SUBJECT: REVISED PRESSURE/TEMPERATURE LIMITS

Re: Palisades Plant

Amendment No. 89
License No. DPR-20

SAFETY EVALUATION BY THE OFFICE OF NUCLEAR REACTOR REGULATION
SUPPORTING AMENDMENT NO. 89 TO PROVISIONAL OPERATING LICENSE NO. DPR-20

PRESSURE - TEMPERATURE LIMITS
FOR HEATUP - TO 1.3×10^{19} nvt

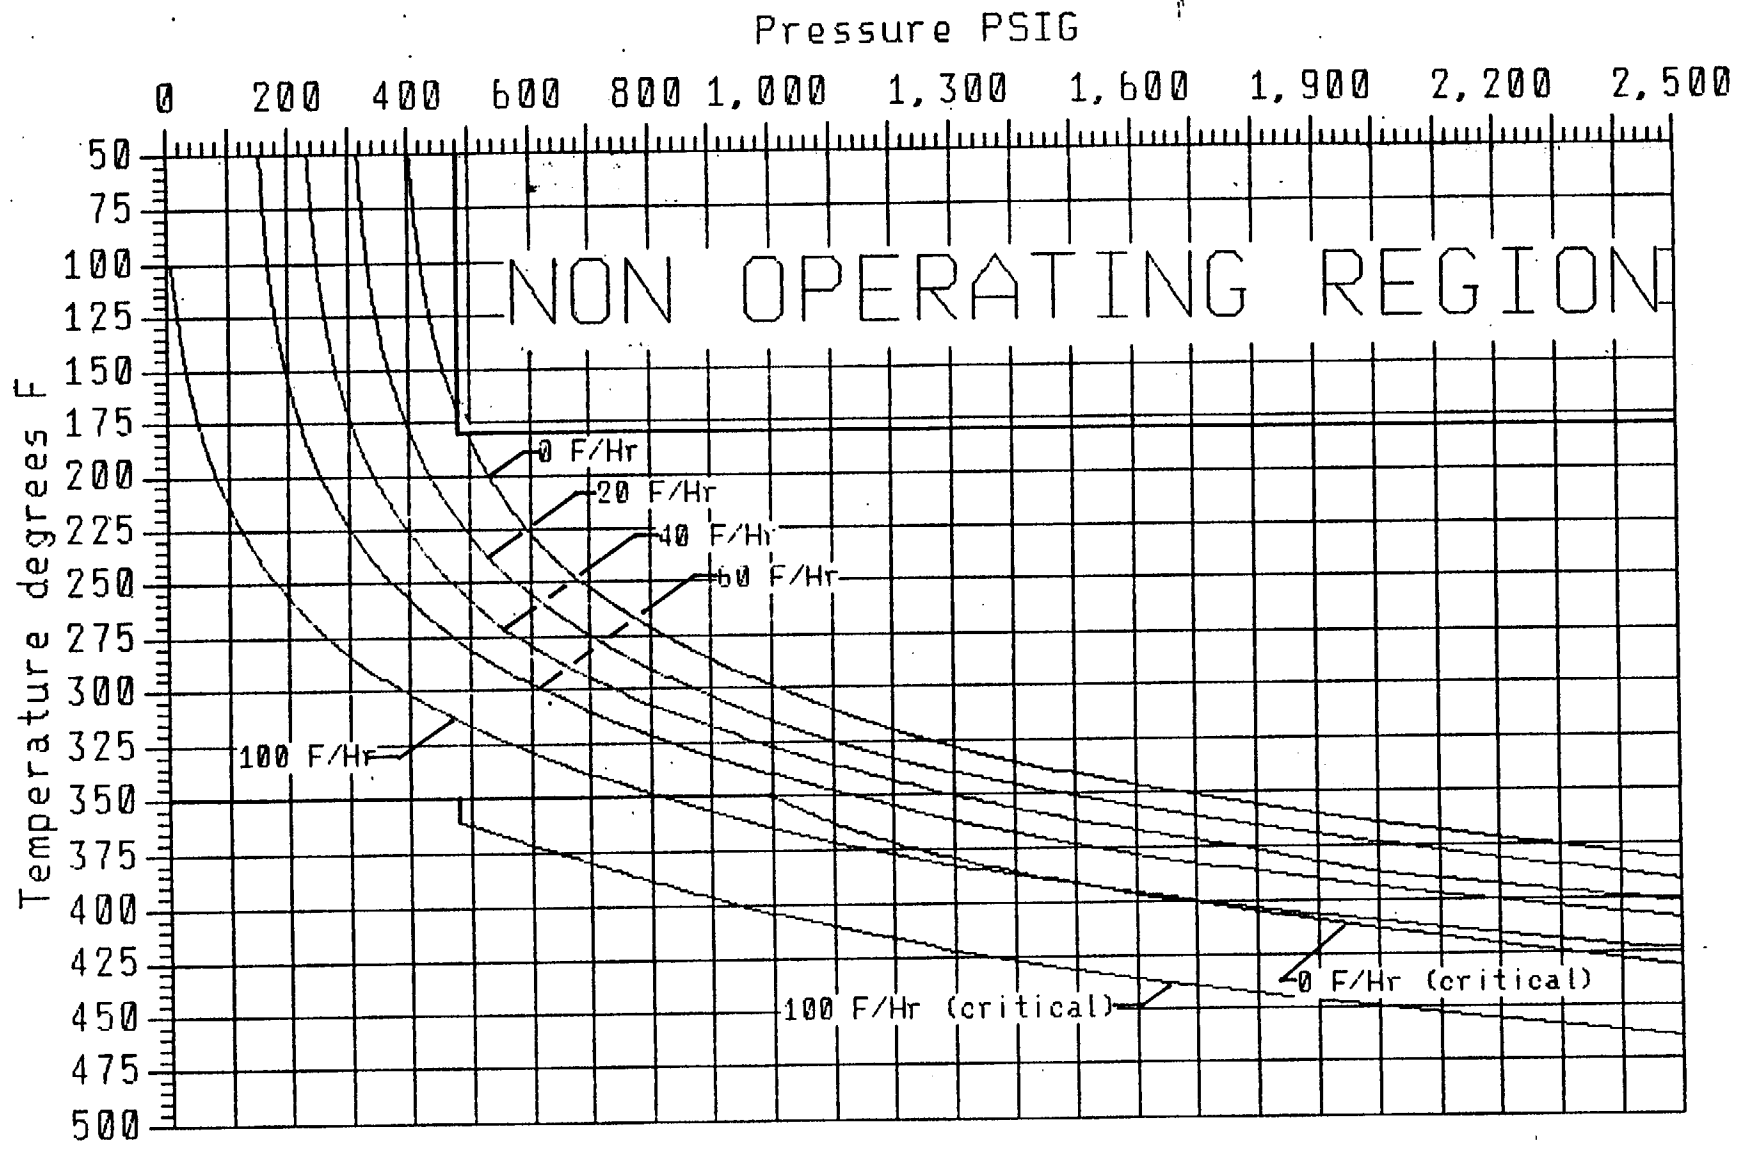
The revised pressure-temperature limits are applicable to reactor vessel inner wall fluences of up to 1.3×10^{19} nvt. The application of appropriate fluence attenuation factors (Reference 10) at the 1/4 and 3/4 thickness locations results in RT_{NDT} shifts of 223°F and 170°F, respectively, for the limiting weld material. The criticality condition

which defines a temperature below which the core cannot be made critical (strictly based upon fracture mechanics' considerations) is 352°F. The most limiting wall location is at 1/4 thickness. The minimum criticality temperature, 352°F is the minimum permissible temperature for the inservice system hydrostatic pressure test. That temperature is calculated based upon 2310 psig inservice hydrostatic test pressure.

PRESSURE - TEMPERATURE LIMITS
FOR COOLDOWN - TO 1.3×10^{19} nvt

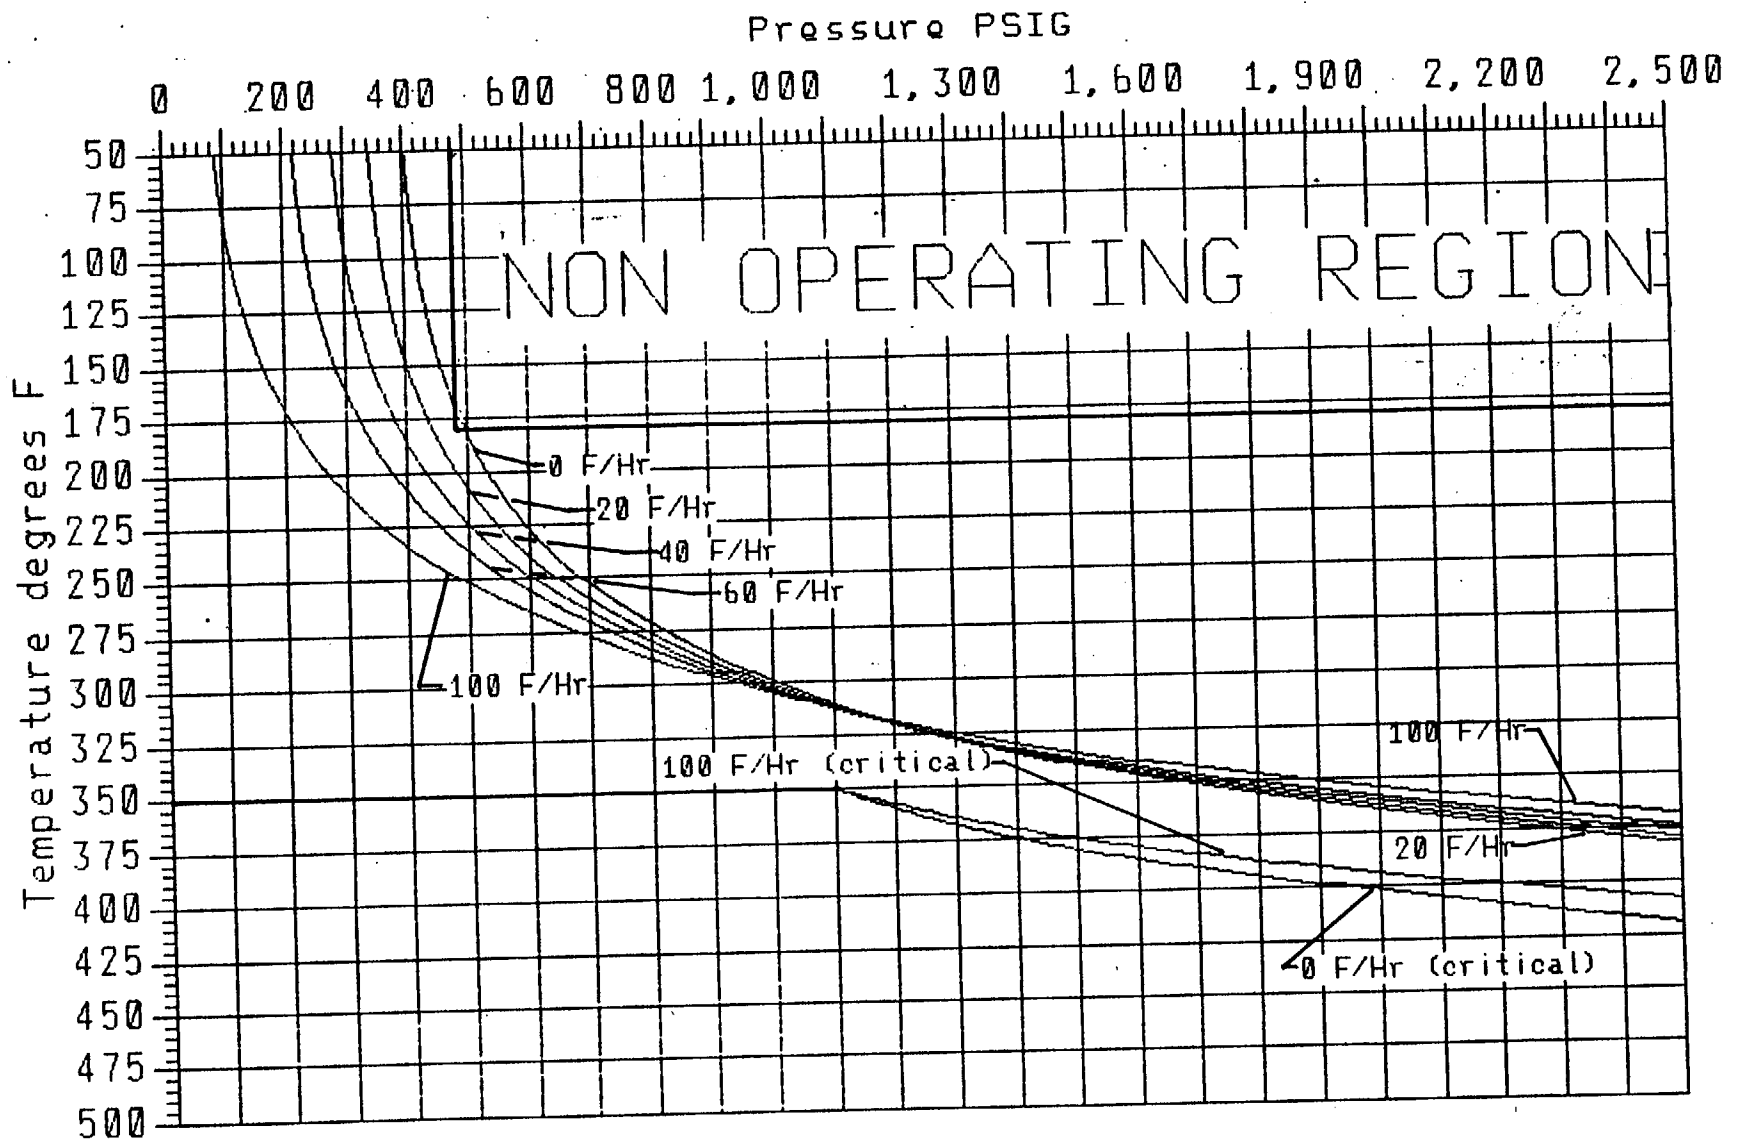
The restriction of heatup and cooldown rates to 100°F/h and the maintenance of a pressure-temperature relationship under the heatup, cooldown and inservice test curves of Figures 3-1, 3-2 and 3-3, respectively, ensures that the requirements of References 6, 7, 8 and 9 are met. The core operational limit applies only when the reactor is critical.
